Access Compliance Report

Public Rights-of-Way (Curb Ramps)

Intersection ID: 27921	Main Street: BLAKENEY_HEATH_RD	Cross Street: CHARNWOOD_CT	Location: SW
ADA ID: 76F38B6DFDC5	Ramp Type: PerpDiag	Initial Pass/Fail: Fail	Overall Compliance: No
Severity Score: 37.5			
Codes/Mitigation Info/Possible Solution		Field Measurements/Component Compliance

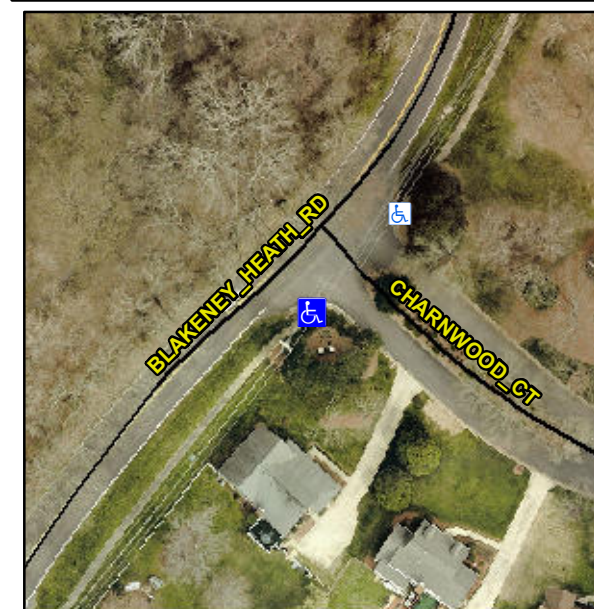
R304.2.2, R304.5.3

Compliance	Description	Data	Compliance	Description	Data
N/A	Ramp Length (in)	48.0	No	Ramp Slope (%)	14.3
Yes	Ramp Width (in)	48.0	No	Ramp XSlope (%)	6.1
N/A	Flare Type LT	N/A	N/A	Flare Type RT	N/A
N/A	Flare Slope LT (%)	N/A	N/A	Flare Slope RT (%)	N/A
N/A	Flare Traversable LT?	N/A	N/A	Flare Traversable RT?	N/A
N/A	Landing Length (in)	N/A	N/A	DWS Provided?	N/A
N/A	Landing Width (in)	N/A	N/A	DWS Contrast?	N/A
N/A	Landing Slope (%)	N/A	N/A	DWS Length (in)	N/A
N/A	Landing X Slope (%)	N/A	N/A	DWS Full Width?	N/A
N/A	Landing Curb? (Y/N)	N/A	N/A	DWS Offset (in)	N/A
N/A	Shared Landing?	N/A			
N/A	Gutter Ponding?	N/A	N/A	Gutter Slope (%)	N/A
N/A	Gutter Lip Ht (in)	N/A	N/A	Gutter X Slope (%)	N/A
N/A	Painted X Walk1?	No	N/A	Painted X Walk2?	No
	X Walk 1 Direction	To NE		X Walk 2 Direction	To NW
N/A	X Walk 1 Width (in)	N/A	N/A	X Walk 2 Width (in)	N/A
	X Walk 1 Slope (%)	0.3		X Walk 2 Slope (%)	2.5
	X Walk 1 X Slope (%)	2.2		X Walk 2 X Slope (%)	1.4

Remove & Replace Curb Ramp With Two New Directional Ramps or Equivalent.
